**Leon Creek WRC Primary Clarifiers Nos. 1 and 2
Rehabilitation Project
Solicitation Number: CO-00751
Job No.: 22-0144**

**ADDENDUM 1
April 25, 2024**

4 CONCRETE COATING LIMITS DETAIL
SCALE: N.T.S.

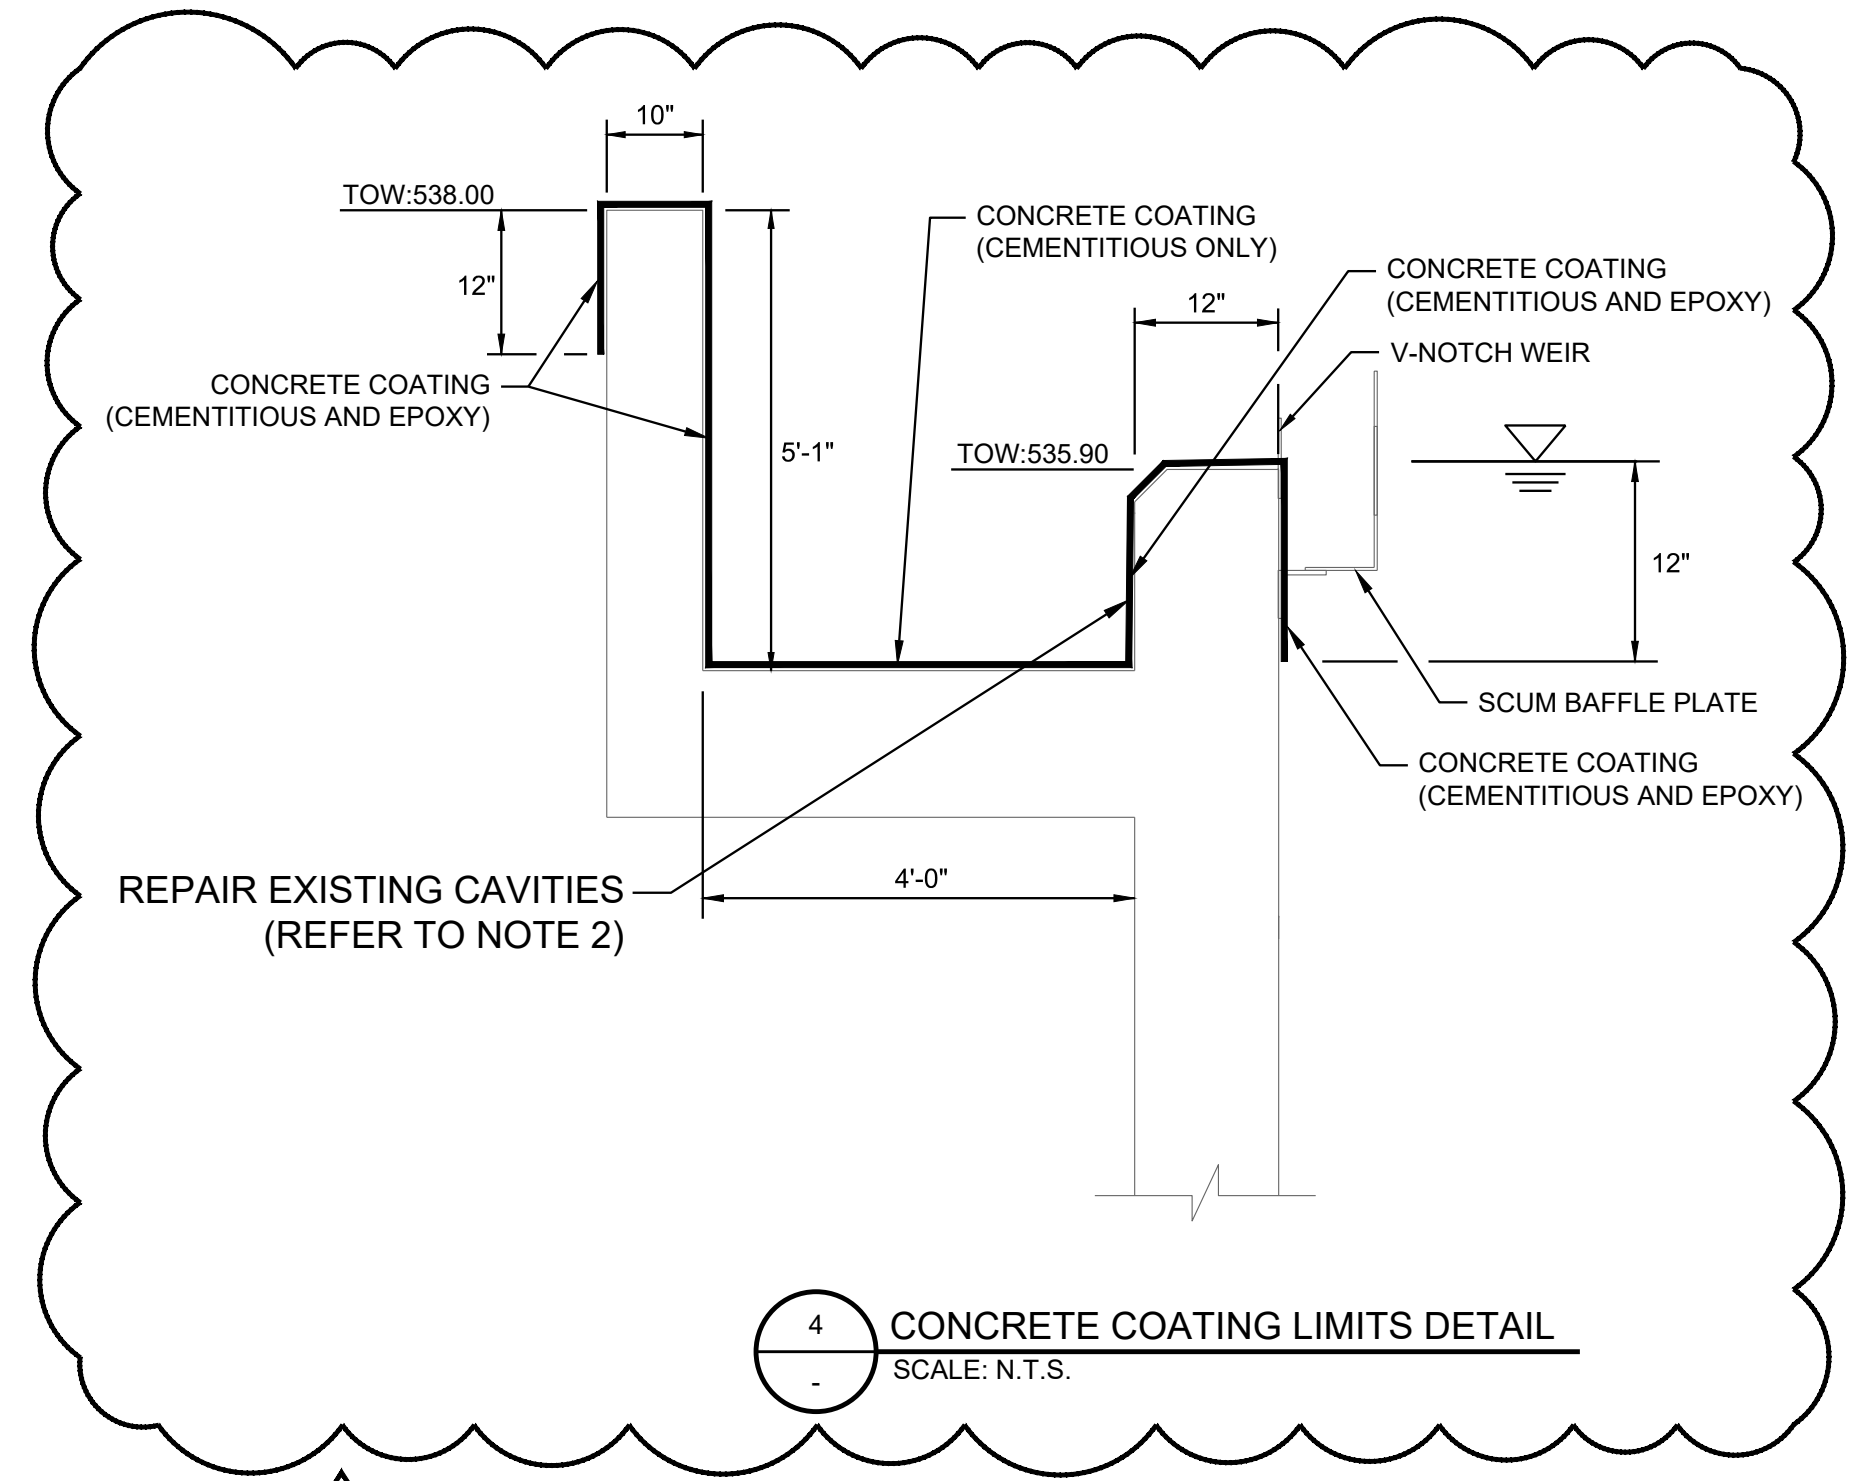
5. Is the Epoxy coating 1 foot under water level of the tank?

11. **Sheet D1 key note E states to plug and seal all holes and cracks in the weir walls. Could we get more clarification on this note? Is the intent of this note to be work for the 3,500 SF structural repair bid item?**

1. **Plan Sheet M3 Primary Clarifier No. 1 and No. 2 Details (1 of 2)**, remove in its entirety and replace it with the revised version attached to this addendum.

Added details and notes regarding repairs to the cavities/holes along the inside perimeter of the primary Clarifier No.1 and No. 2 Launder Wall.

Coating requirements and limits are shown on Sheet M3 and M5. The cementitious and epoxy coating shall be applied to 1-ft below the water surface elevation as shown on Sheet M3, Detail 4.

Primary Clarifier No. 1 and 2 has a number of small holes along the inside perimeter of the launder wall. These holes are approximately 1 to 2-inch wide by ½ to 1-inch deep and are spaced approximately 3 to 4-ft on centers. Use a low shrinkage, fiber reinforced NSF/ANSI Standard 61 Repair Mortar, EUCOREPAIR V100 and liquid latex bonding agent EUCOWELD 2.0 by Euclid Chemical or approved equal.

Plan Sheet M3, Detail 4 was revised to provide additional clarification. No separate pay item is provided for this work. Refer to Changes to Plans No. 1 of this addendum.
